HUNTER VALLEY GLIDING CLUB CO-OP LTD

22 September 2025

RE: RESPONSE TO THE EIS FOR HUNTER TRANSMISSION PROJECT

Figure 1. Warkworth Airfield Obstacle Limitation Surface for mining operations

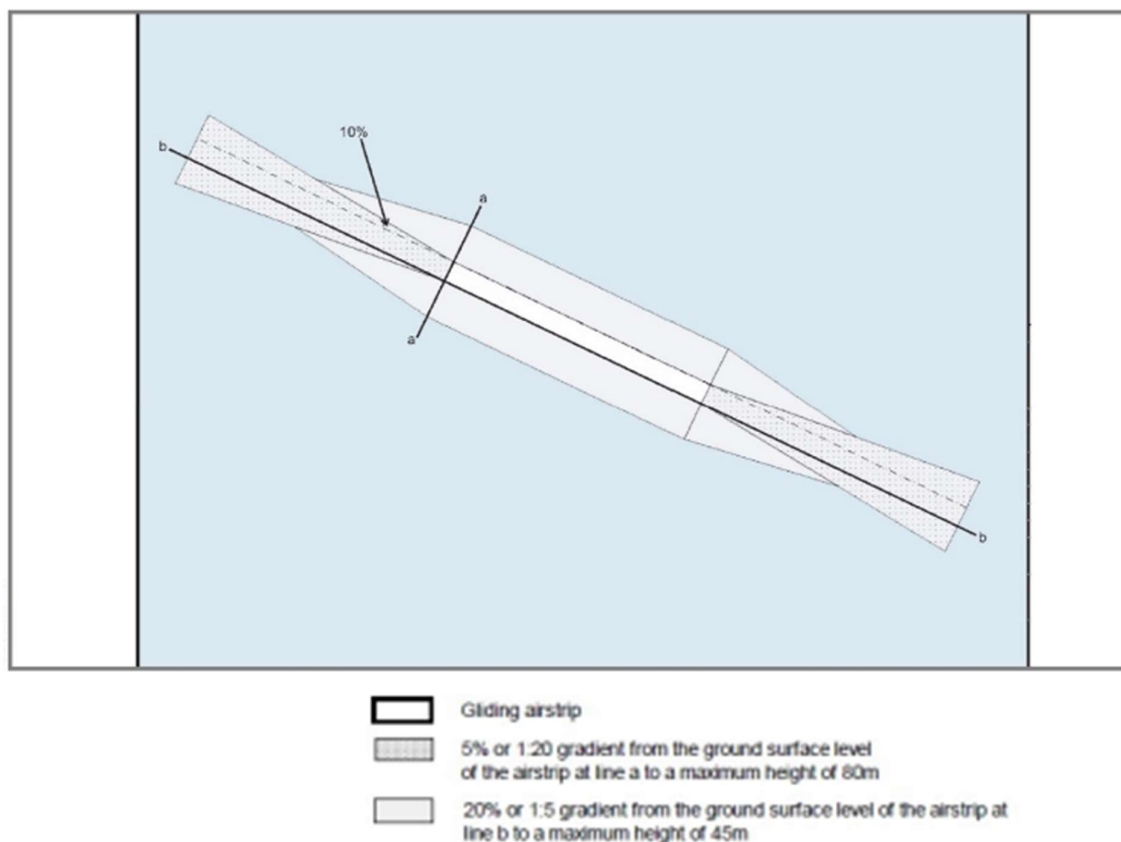
The existing OLS extends for 1.6 km (1 in 20 to an 80 m height) beyond the boundary of the airfield in a direction parallel to the runway alignment. In the direction perpendicular to the alignment of the airfield the OLS extends for 225 m (1 in 5 to a 45 m height). There is a 330 kV transmission line, approximately 50 m high, located 275 m from the edge of the airfield's south-western boundary. Our experience with this 330 kV transmission line is that while this is outside our mining surface OLS, it is

in a position that during emergency exercise training is uncomfortably close. It also places a limitation on our future operations by constraining them to the current orientation of the landing strip.
